8 Jan 1996

SOURCE : Stuart Dunstan, Siemens Ltd
TITLE : Comments on references to H.245 in H.310 and H.323
PURPOSE : Proposal

Figure 1. Representation of H.245.

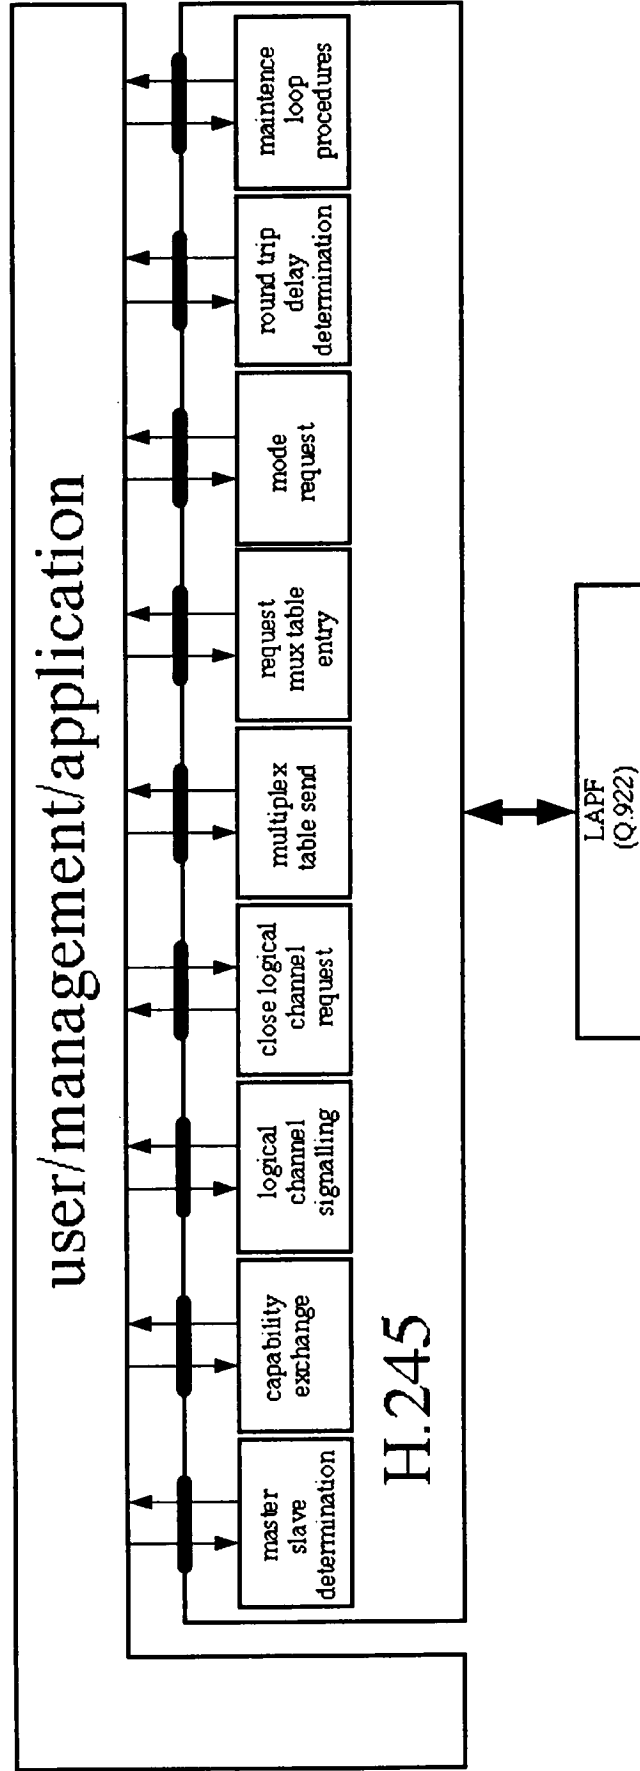
In introducing H.245 it may be unwise to emphasise this classification of messages for the following reasons,

- i) system recommendations should emphasise the protocol entity nature of H.245. H.245 consists of a number of independent protocol entities e.g. master slave signalling entity, logical channel signalling entity, etc. Each protocol entity consists of syntax (messages and fields), semantics, and well defined procedures. Global message classification is in itself not an important aspect.
- ii) the statement appears to give mandatory requirement to message procedures based on this classification. This may conflict with procedures defined in section 8. Section 8 defines the interaction with the user, what actions shall be performed at each terminal, what messages may be sent, and when messages may be sent. Further specification is not required.

Figure 1 shown overleaf provides an overview of H.245.
